## Silicon Anomaly

## ADuC7033

This anomaly list describes the known bugs, anomalies, and workarounds for the ADuC7033 integrated precision battery sensor. The anomalies listed apply to all ADuC7033 packaged material branded as follows:

First Line ADuC7033  
Second Line BSTZ 8L or BCPZ 8L

Figure 1.

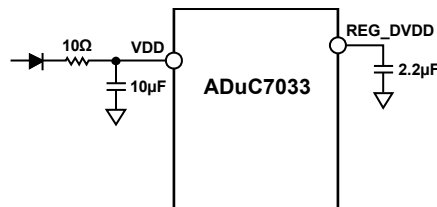
| <b>Issue:</b>      | Under particular conditions, the POR does not release the reset signal, that is, the ASIC remains in reset until a power cycle occurs. This POR issue only occurs under three specific and coincident power-on conditions: <ul style="list-style-type: none"> <li>• Fast ramp on VDD, nominally faster than 100 <math>\mu</math>s from <math>V_{init}</math> to 12 V</li> <li>• Initial value of VDD (<math>V_{init}</math>) <math>\sim</math>1.2 V</li> <li>• Voltage on REG_DVDD at time the VDD ramp is reapplied <math>\sim</math>175 mV</li> </ul>                                                                                                                                                                         |

| <b>Workaround:</b> | A fast VDD ramp (that is, ramping from $\sim$ 1.2 V to 12 V in $<$ 100 $\mu$ s) is required as one of the conditions to initiate the reported POR issue. Analog Devices recommends careful selection of external power supply decoupling components to ensure that the VDD supply ramp rate can always be guaranteed to be $>$ 100 $\mu$ s under all VBAT power-on conditions. Specifically, in modules that already incorporate a series resistor and decoupling capacitor to ground on the VDD line between the reverse protection diode and the VDD pin (see Figure 1), choose the series resistor/decoupling capacitor combination to give an RC time constant of at least 100 $\mu$ s, such as 10 $\Omega$ and 10 $\mu$ F. |

Alternatively, in the specific case of customer modules where the VDD decoupling capacitor cannot be increased beyond 4.7  $\mu$ F, then increasing the series resistor to 20  $\Omega$  and increasing the REG\_DVDD decoupling capacitor from 2.2  $\mu$ F to 10  $\mu$ F also slews the VDD supply power-on ramp to  $\sim$ 200  $\mu$ s. This is also an appropriate and recommended containment measure.
